Errata IBC Chapter 2 Definitions
--

Code/Standard: IBC 2021

Applies to following Printings: 1st and 2nd

Section/Table/Figure Number: 2113.19

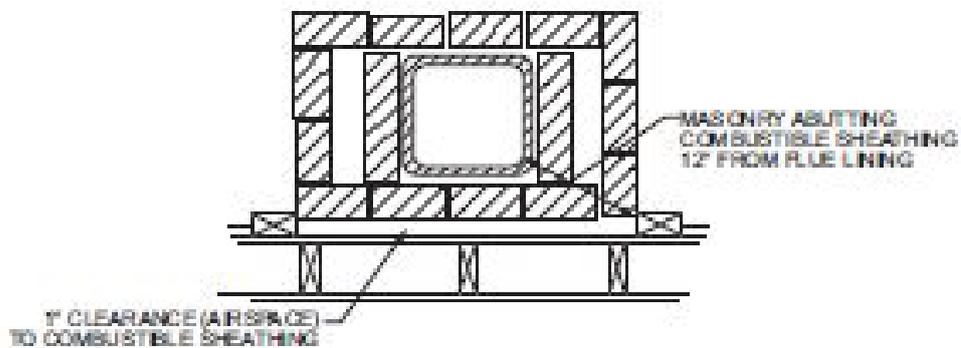
Replace Figure 2113.19 with the following:
